Noises in B-Pillar Area - Correct Felting of B-pillar Trim Panel (SY 61/26)

Model Line: **Taycan (Y1A/Y1B/Y1C)**

Model Year: **from 2025**

Concerns: **Reworking the B-pillar trim panel in the event of noises**

B-pillar trim panel

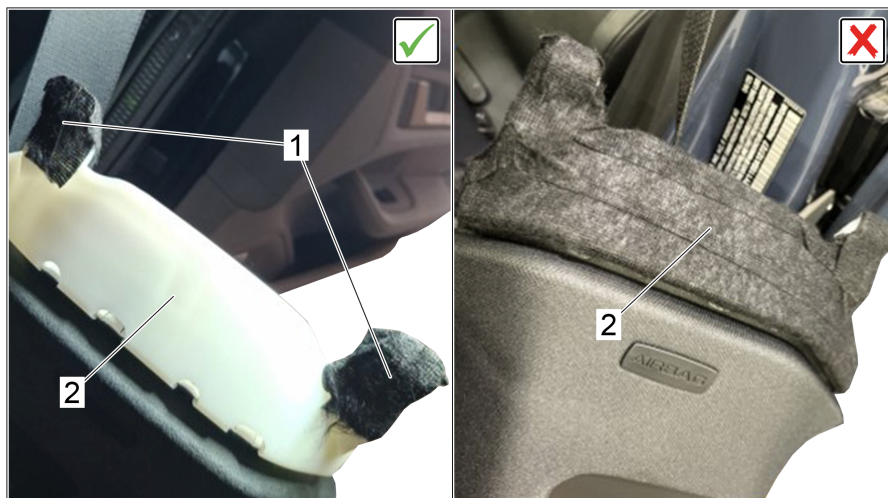
If the B-pillar trim panel on the airbag ramp is reworked/taped with felt, the **airbag triggering behavior can be impaired**.

Remedial Action: In the event of a noise complaint from the area of the B-pillar in which the upper B-pillar trim panel in the inside is to be reworked with felt, **only -1-** mask the **guide pins**.

The airbag ramp -2- must not be covered with felt.
